ALERT SERVICE BULLETIN

SUBJECT: ALERT SERVICE BULLETIN 206L-87-47, REV. "C", TAIL-BOOMS, P/N 206-033-004-3/-11/-103/-45, INSPECTION AND MODIFICATION OF

This revision is issued to clarify the intent of this bulletin by the addition of a NOTE in Part I, Paragraph 3, and to make minor changes to text and graphics.

MODEL AFFECTED: 206L, 206L-I, 206L-III
SUBJECT: TAILBOOMS, P/N 206-033-004-3/-11/-103/-45 PERIODIC INSPECTION OF, MODIFICATION OF

FIGURE I

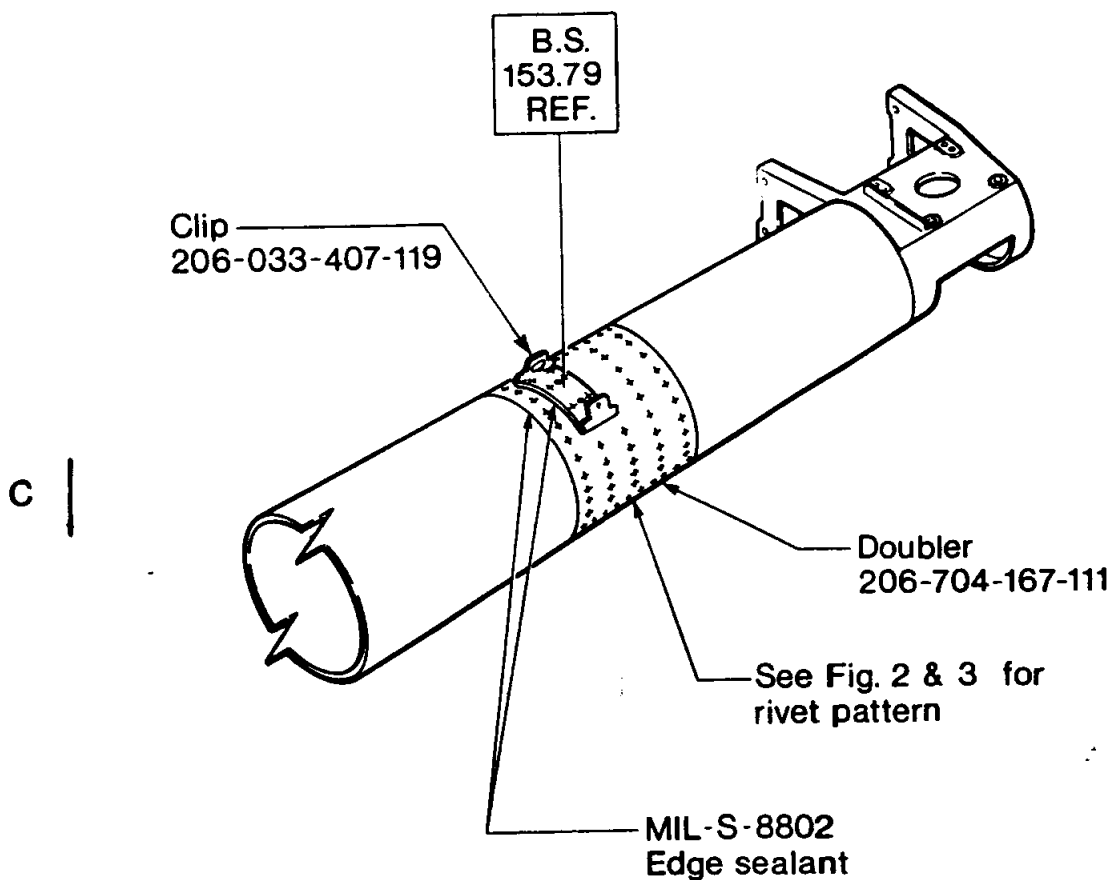
206L SERIES TAILBOOM
CLIP MODIFICATION
B.S. 153.79

FIGURE 2

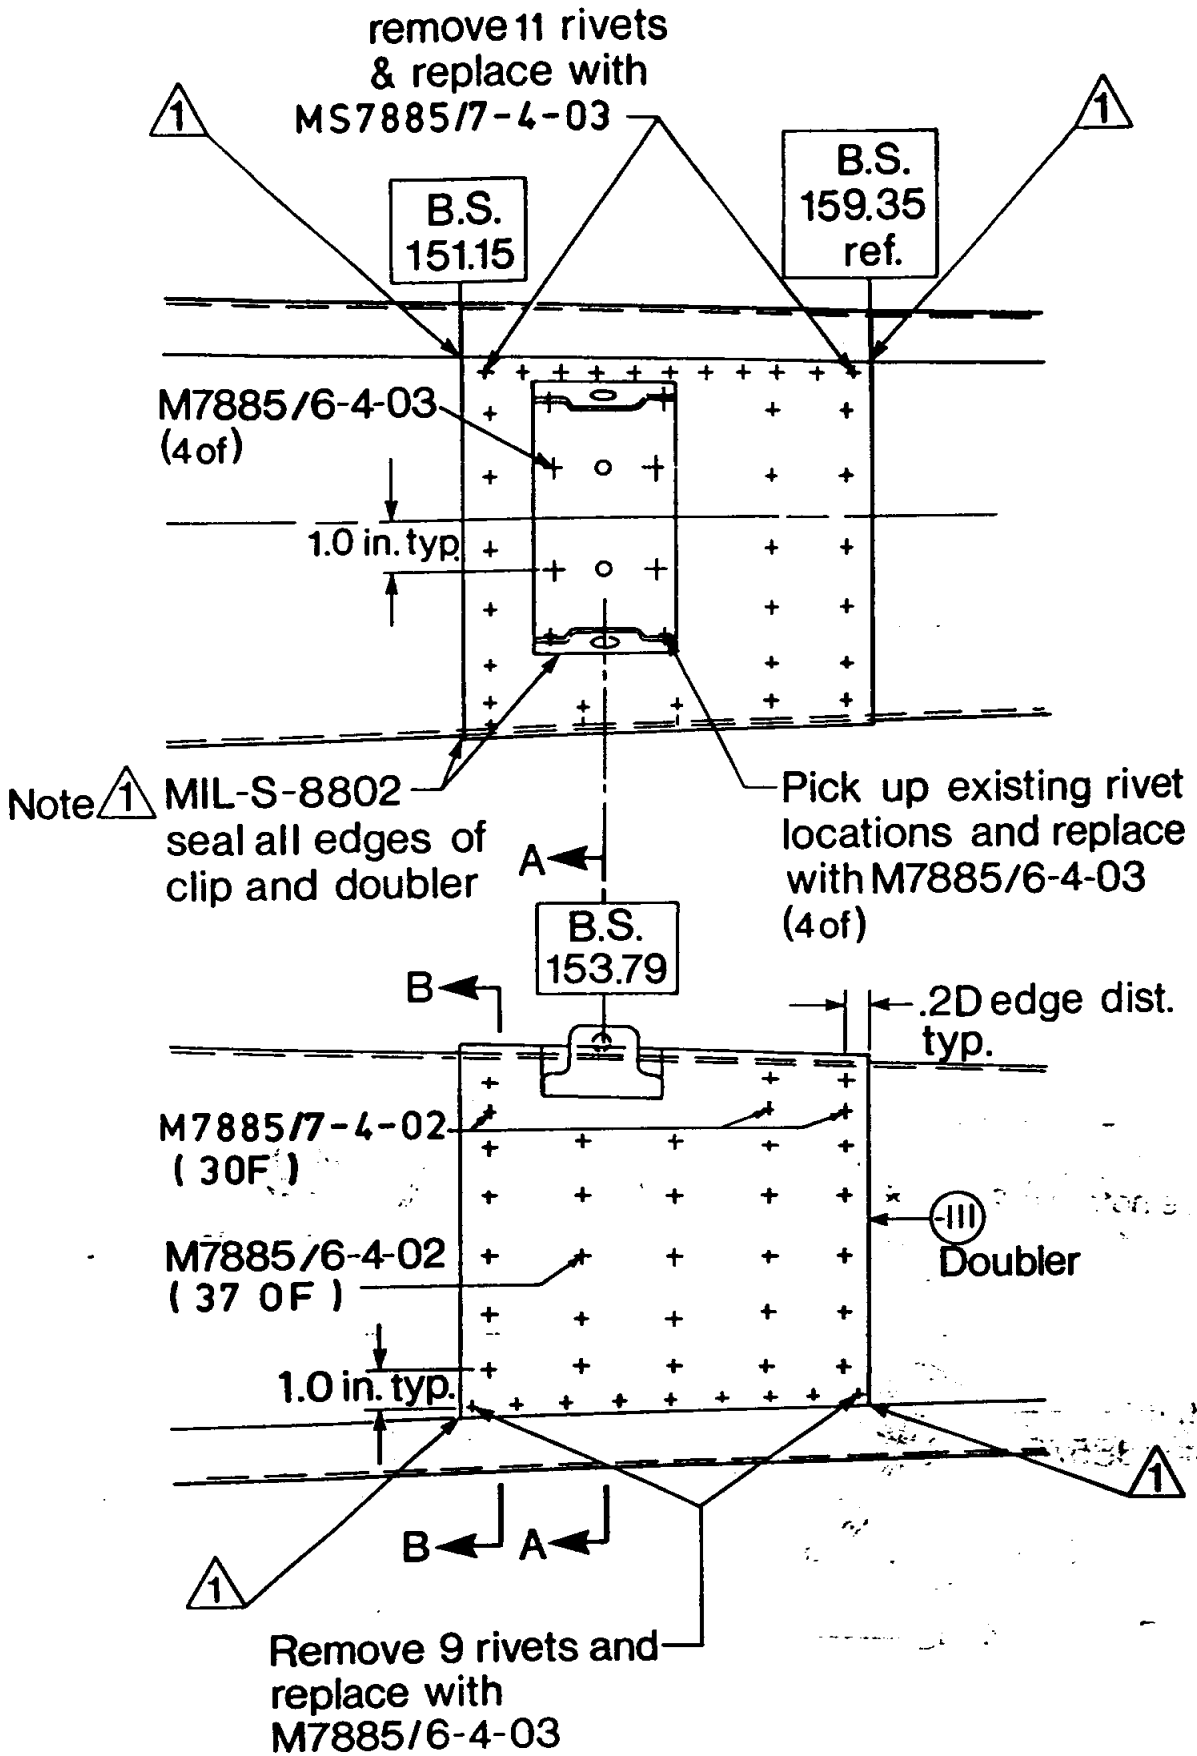
- 4) Remove rivets along upper and lower skin seams between B.S. 151.15 and B.S. 159.35. (Approx. 11 rivets on upper and 9 rivets on lower.) See Fig. 2.
- 5) Strip paint from area of top skin between B.S. 151.15 and B.S. 159.35 and from new clip faying surface.
- 6) Fit doubler P/N 206-704-167-111 to tailboom such that leading edge of doubler is at B.S. 151.15 and drill to match existing holes along seams and 4 existing clip rivet holes.

- 1) Doubler rivet rows are spaced 1.0 inch from seam rivet lines. See Figure 3, Sec. B-B.
- 2) Five (5) rows of rivets are equally spaced from front to back of doubler. Maintain a 2D edge distance. See Figure 2.
- 8) With doubler held in place, position saddle clip, P/N 206-033-407-119, at B.S. 153.79 to align with T/R drive shaft cover and pickup on 4 existing clip rivet holes. In addition, drill two rivet holes 1.0 inch each side of the longitudinal C/L of tailboom. Maintain 2D edge distance. See Figures 2 and 3, Sec. A-A.
- 9) Drill all holes in tailboom, doubler and clip to proper rivet hole size. Countersink to a max. depth of .038 inch in 14 places for M7885/7 or NAS1739B4 rivets (see Figure 2 and 3 for locations). Remove clip and doubler and deburr holes both sides including tailboom skin.

- 13) With adhesive applied to faying surfaces of doubler and tailboom, position doubler and secure using appropriate rivets, per Figure 2.
- 14) Apply adhesive to top of doubler and to clip faying surfaces, position clip on doubler and secure to tailboom using 8 M7885/6-4-03 rivets.

- 17) Apply a brush coat of alodine to bare aluminum areas and to rivet heads.
- 18) Seal all edges of doubler and clip using MILS8802. (See Fig. 2.)
- 19) Prime using polyamide epoxy primer and repaint affected area. | "C"

FIGURE 3

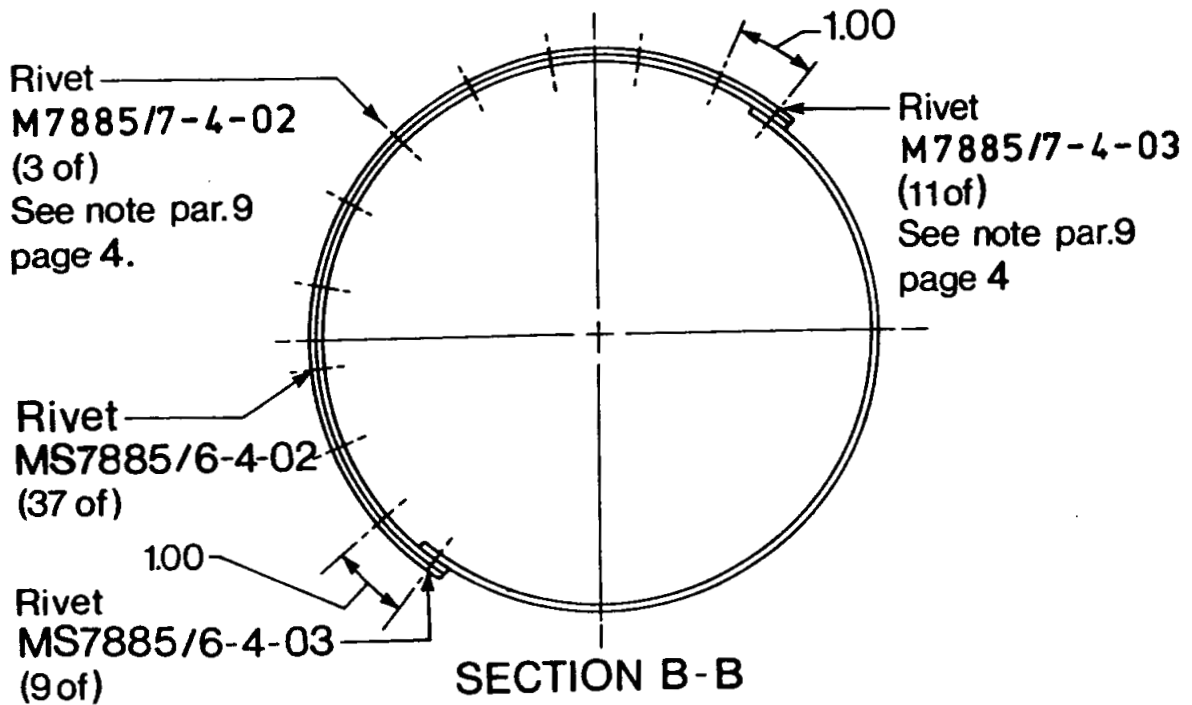
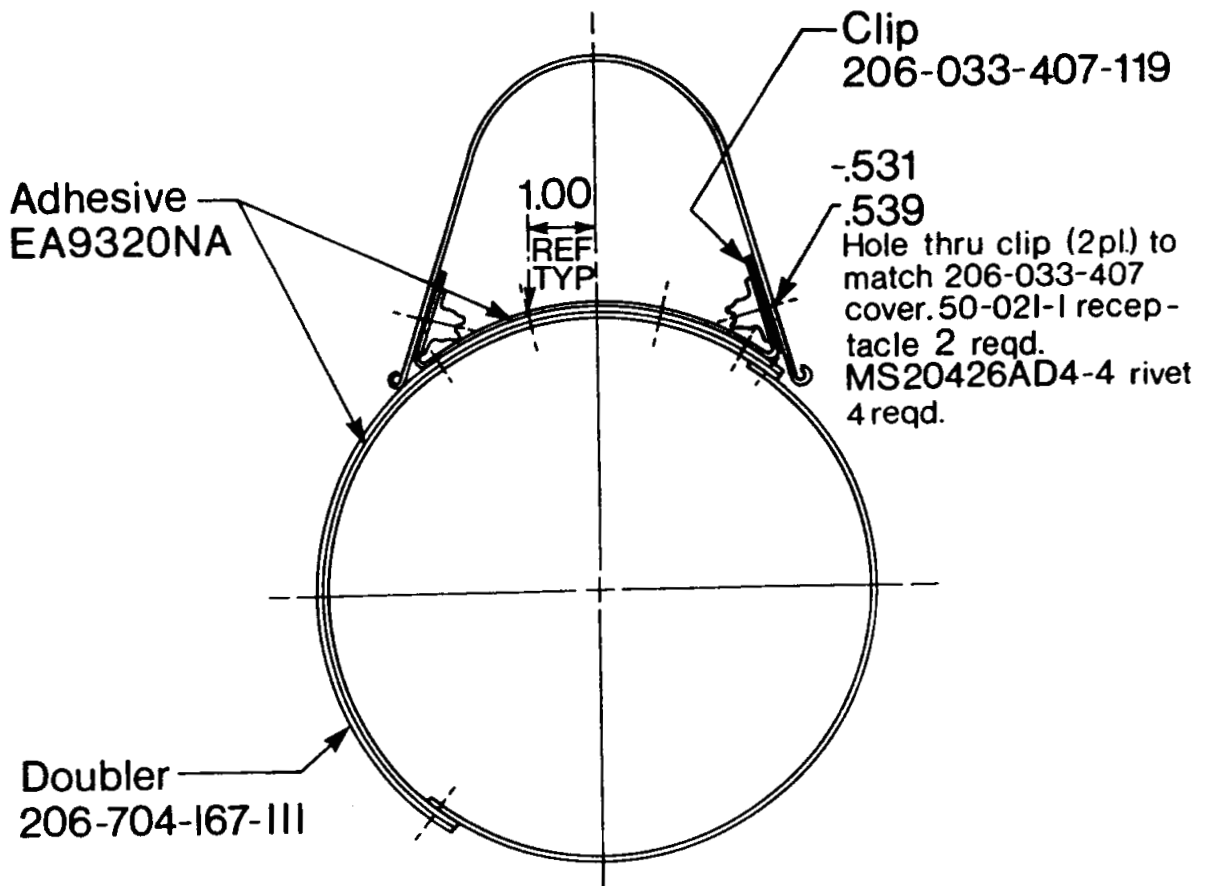
- 16) Install receptacle P/N 50-021-1 on clip. Position to match P/N 206-033-407 cover and secure using MS20426AD4-4 rivets. (See Fig. 3), Sec. A-A. Ensure that fastener stud does not come into contact with clip saddle when secured.

FIGURE 4

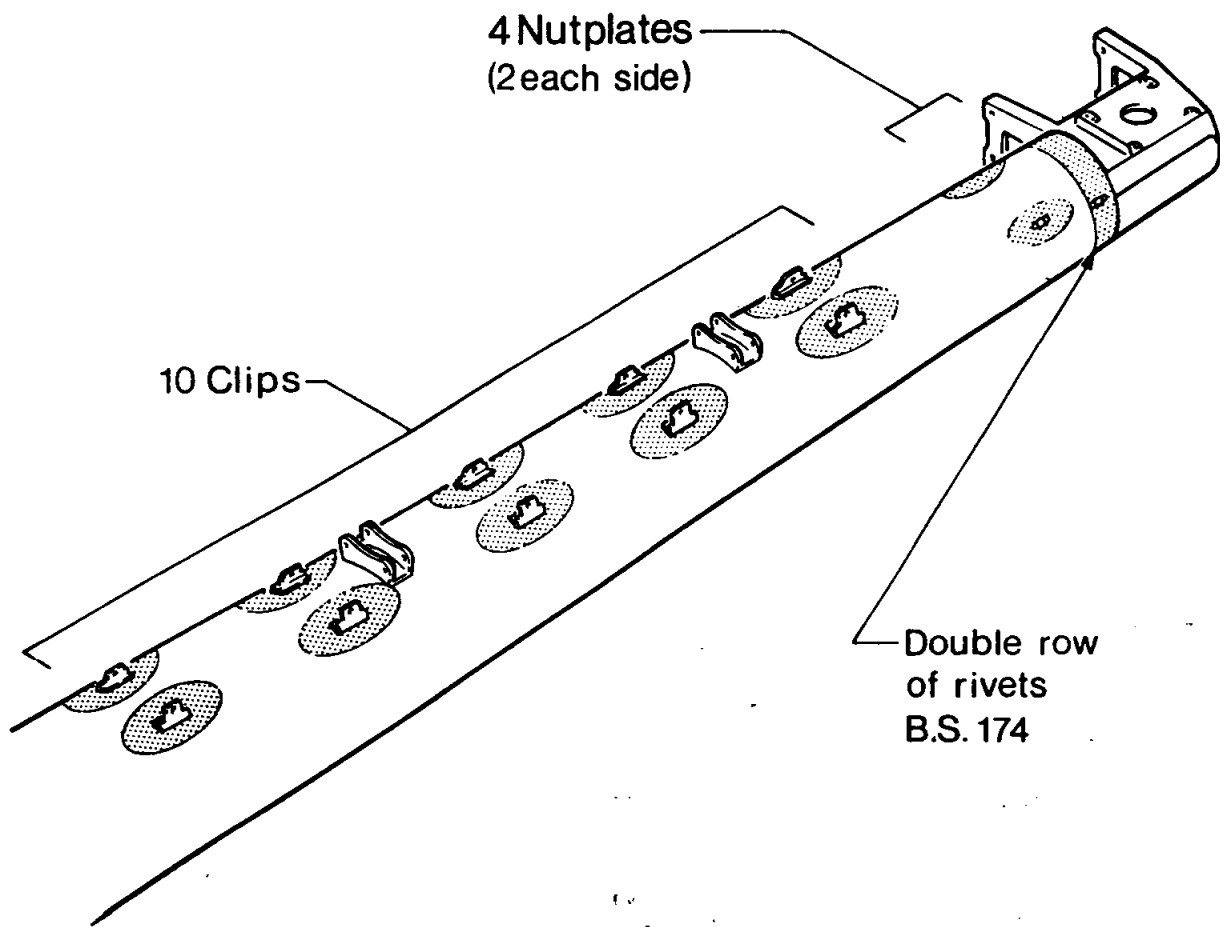
- 3) Prior to cleaning, use a min. 5 power magnifying glass to inspect for cracks and signs of developing cracks at the following locations: (See Fig. 4)

- A) Aft of stabilizer assy, around rivets which attach the tail rotor drive shaft cover retention clips to the tailboom.
 - B) Area of tail rotor gearbox fairing attachment nut plate rivets.

- C) area of double row of rivets which attach the tail rotor gearbox support fitting to the tailboom (B.S. 174).
- 4) Clean entire tailboom taking particular care to remove all grime and dirt in specified area of inspection and repeat min. 5 power inspection as per sub-paragraph 3.

FIGURE 5

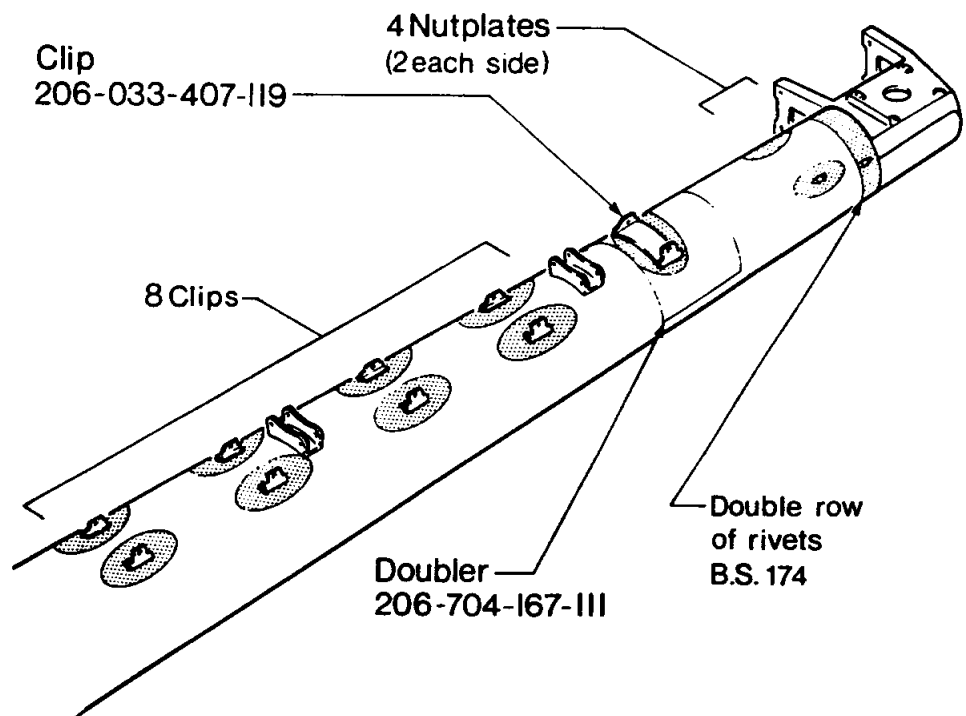
- 1) Inspect as per PART II. (Refer to Fig. 5)
- 2) Inspect doubler and clip edge sealant for integrity. Reseal as required. (See Fig. 2)
